Amendments to the Drawings:

REMARKS/ARGUMENTS

Annotated Sheet Showing Changes

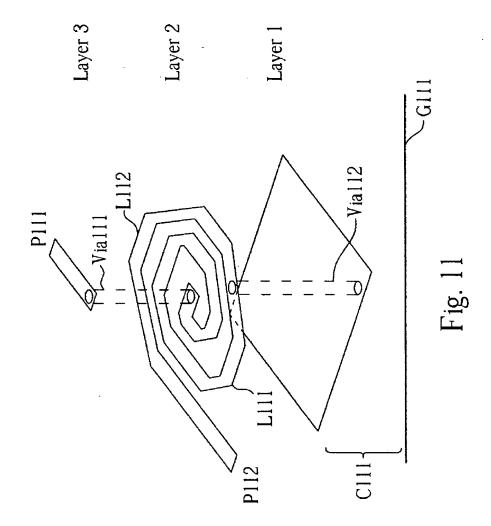
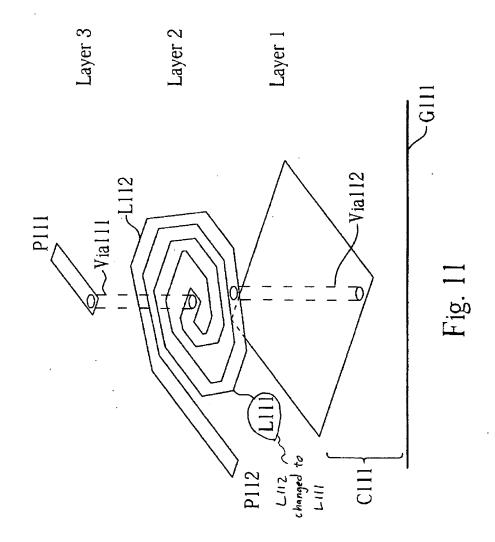
Figures 11 and 12 have been amended to include the following reference signs: 111 and 121. These changes correspond with the specification, and no new matter is added.
